HISTORIC AND DESIGN REVIEW COMMISSION

September 02, 2015

HDRC CASE NO: 2015-341
ADDRESS: 327 CEDAR ST
LEGAL DESCRIPTION: NCB 2963 BLK 11 LOT E 96 FT OF 9 OR A9
ZONING: RM4 H HS
CITY COUNCIL DIST.: 1
DISTRICT: King William Historic District
LANDMARK: House
APPLICANT: Gustavo Mendoza
OWNER: Sharon Lee
TYPE OF WORK: Solar panel installation

HDRC CASE NO: 2015-340
ADDRESS: 107 CROFTON
LEGAL DESCRIPTION: NCB 941 BLK 4 LOT 6 AND N IRR 21.18 FT OF 7
ZONING: RM4 H HE RIO-4
CITY COUNCIL DIST.: 1
DISTRICT: King William Historic District
LANDMARK: Engelke / Reifel House
APPLICANT: Ginger Ardid
OWNER: Michael & Barbara Taylor
TYPE OF WORK: Window modifications / replacement
REQUEST:

Street View of Solar Array

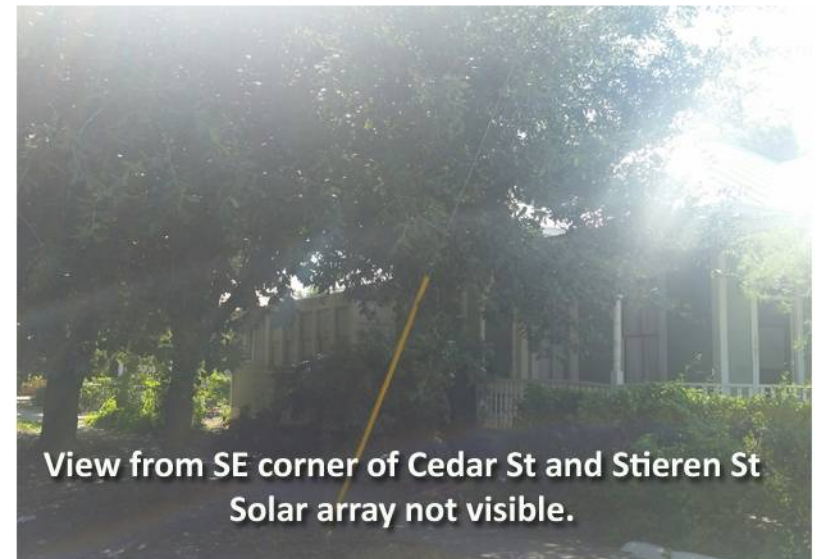
- a. The applicant has proposed to install a solar photovoltaic system attached to a sloped, ground mounted structure to be approximately eleven feet in height at the top slope and approximately seven feet in height at the bottom slope. According to the Guidelines for New Construction 6.C.i., an appropriate location for solar collectors is through the form of a ground mounted system where a roof mounted system is not appropriate. The applicant's proposed location is consistent with the Guidelines.
- b. While the majority of the proposed structure will not be seen from the public right of way at Cedar, it will be seen from the public right of way at Stieren. Staff finds that this proposal appropriate given there will be some visual cover by existing vegetation and the fact that the proposed system will not be mounted to the historic structure.

Staff recommends approval based on findings a through b with the stipulation that the overall total construction height of the mounting system not exceed eleven feet in height.

Proposed Layout
6.24 KW Solar PV
24 x 260W Panels

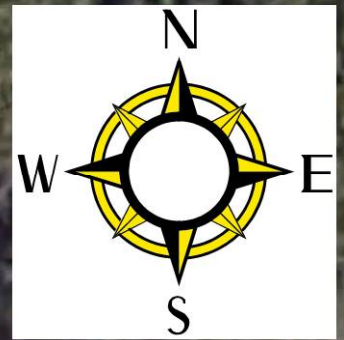
The applicant is requesting a Certificate of Appropriateness to install a solar photovoltaic system attached to a sloped, ground mounted structure to be approximately eleven feet in height at the top slope and approximately seven feet in height at the bottom slope. The applicant has proposed to install the solar photovoltaic system in the rear yard.
